marantz® SERVICE BULLETIN		Date: 15-May.-2003	Model: DR6000, DR6050, CDR631, CDR500
		Page: 1 / 1	REF.NBR: MZ02-031
Circulation:	Application:	Subject: Replace the Chip capacitor on the CDR module of MAR770/MAR775.	
x for information customer complaint in case of service mandatory	See Below		
		Int.ref:

marantz® SERVICE BULLETIN		Date: 22-Nov-01	Model: DR4050/DR6000/DR605 0CDR500/CDR631
		Page: 1/1	REF.NB MZ01-019
Circulation:		Application:	
x for information customer complaint in case of service mandatory		See below	
		Subject: Improvement for inoperable all buttons	
		Int.ref:

marantz® SERVICE BULLETIN		Date: 15-May.-2003	Model: DR6050,CDR500
		Page: 1 / 1	REF.NBR: MZ02-035
Circulation:		Application:	
x for information customer complaint in case of service mandatory		See Below	
		Subject: Miss clamp problem of CD single	
		Int.ref:

This is Pos.No.3114

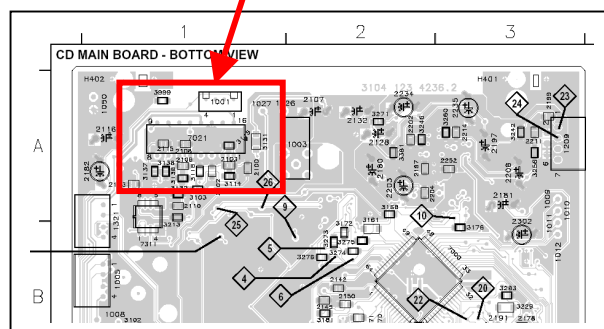
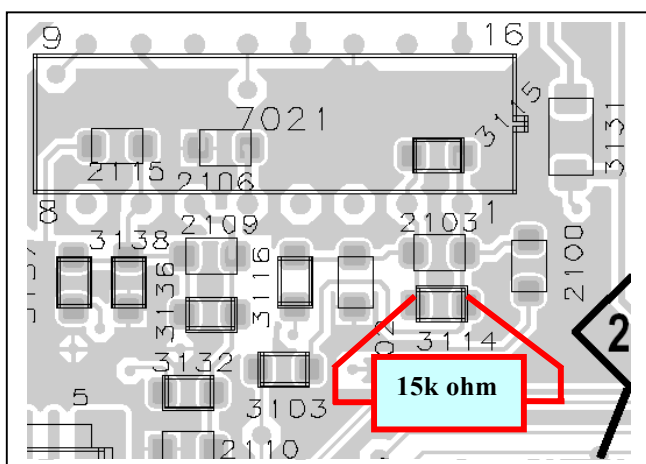
[PHENOMENON]

The OPEN/CLOSE movement of disc tray is fast, It may become a CD single [8cm(3in.)] clamp defect.

15k ohm resistor is soldered to the **Pos.No.3114** in parallel.

The object of PCB: CD MAIN BOARD of CD Module MAR1250
(Refer to the CDR500 service manual 2-13 page of MAR1250.)

15k ohm GD05153160
